Areas of Plan Called into Question as being "Open Space"

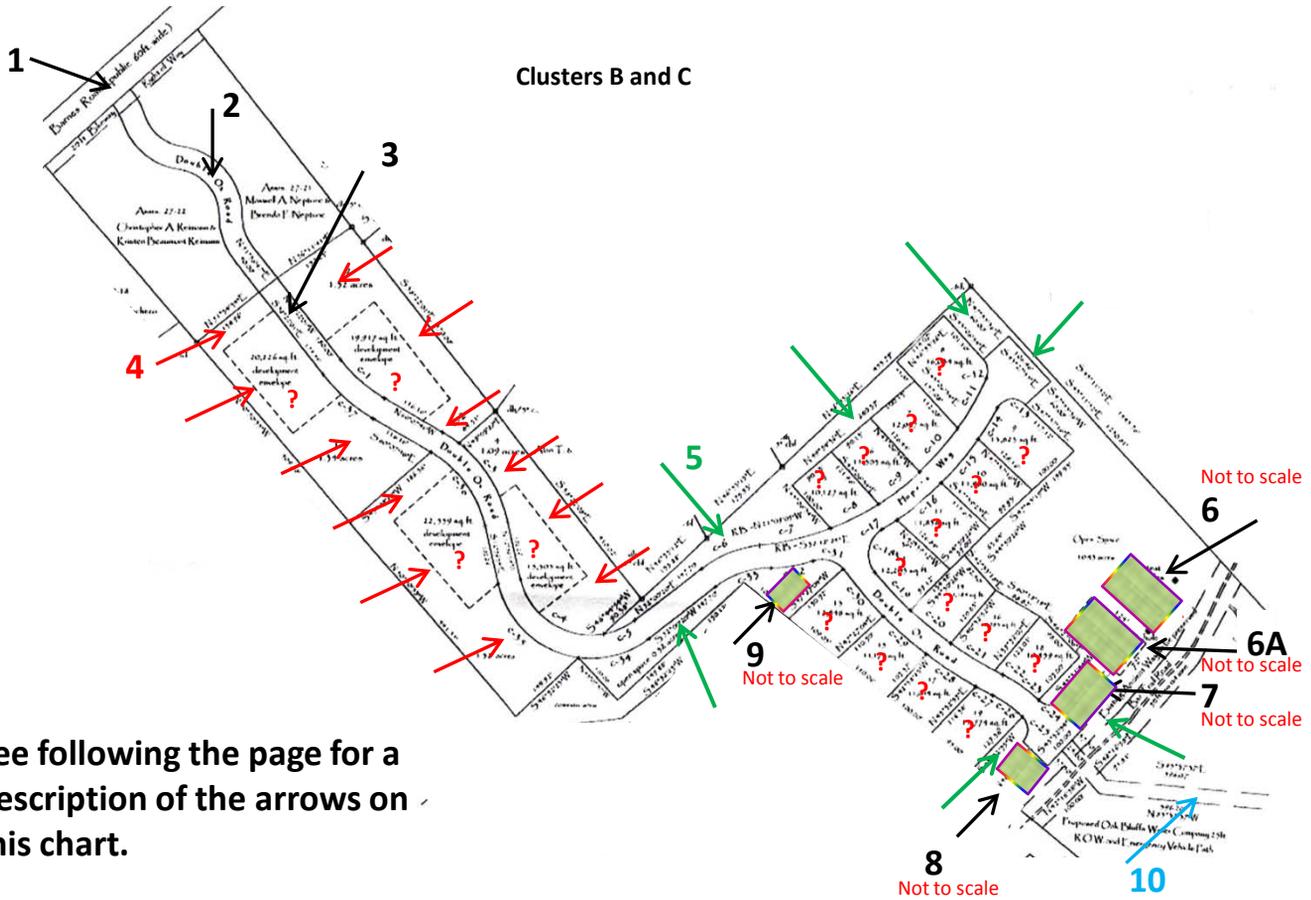
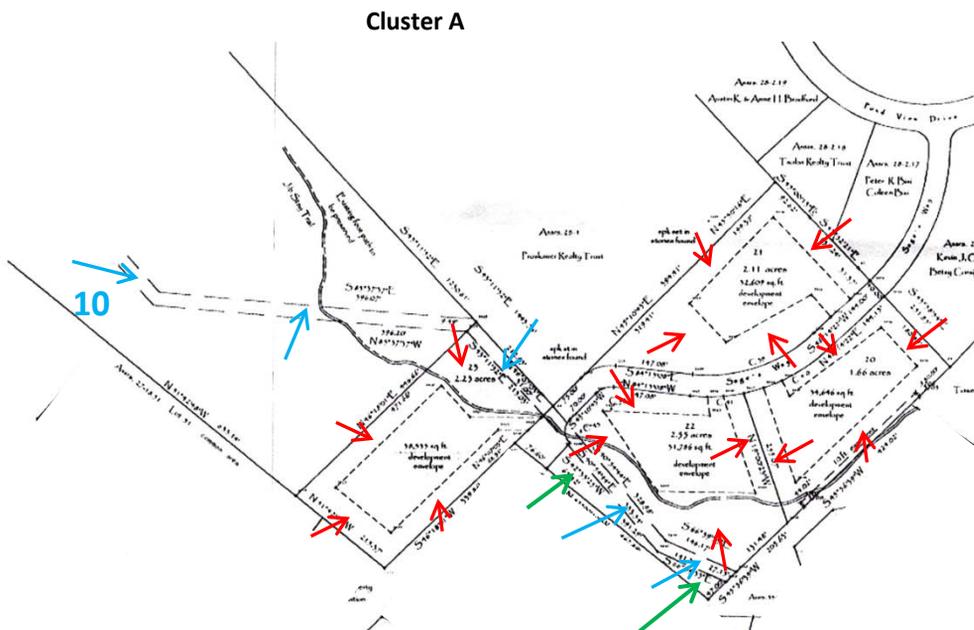
1. The arrow points to the area of the bike path that will be cleared, but is not likely to have been removed from the total Open Space claimed. If so, where is it itemized?

2. The arrow points to the road area leading to Barnes Road which was not likely to have been removed from the total Open Space claimed. If so, where is it itemized?

3. The arrow points to the 40 foot ROW for all roads. It is not known if the widening of the ROW from 30 to 40 feet was considered in the final Open Space calculation. If so, where is it itemized?

4. The red arrows in each of the backs and side yards as well as some front yards call your attention to those portions which are claimed as Open Space, but are really yard spaces or setback spaces which cannot be claimed Open Space.

5. The green arrows call your attention to the small irregular shaped portions of land of no significant value for Open Space.
6. The arrow points to an area that is not designated on the plan which should be available for the reserve drain field and cleared of trees for the Shared Septic System. This reserve space is mandated on the engineer's drawing.

- 6A. The arrow points to an area on the plan for the drain field that will be cleared of trees, but is in Open Space which was not likely to have been removed from the total Open Space claimed. Where is it itemized?

7. The arrow points to an area not designated on the plan for the Shared System's components and the necessary driveway which will be cleared of trees and cannot be claimed as Open Space. Where is it itemized?

8. The arrow points to a parking area for the trails at the end of Double Ox Road... the MVC condition 12.5 is not totally clear; however, the hammerhead style end of the road is designed to allow emergency vehicles room to turn. Therefore, it is contrary to public safety that parking should be allowed in the hammerhead, and the parking is necessarily in the area shown on this marked-up map at arrow 8. I'm not certain how this area should be classified. Open Space?

9. I arbitrarily placed arrow 9 at this location, because the LRD's papers describe a Community House that will be on a 5000 SF area. There are no 5000 SF lots in Cluster C. LRD also said that they will build the shell at the beginning of construction, but did not say where. This is land that is not Open Space and should be removed from the calculation. Where is it itemized?

10. The light blue arrows point out the 25 ROW that has been designated as an Emergency Road and for use by the Water Department. Its entire length will be cleared of trees and is likely to

have been considered Open Space on the Definitive plan. This area should be removed from the Open Space calculation. Where is it itemized?

(?) The question marks (?) on the lots of Clusters B and C remind you that there must be areas for individual septic systems on each of these lots due to the MVC condition regarding failure of the Shared Septic System.
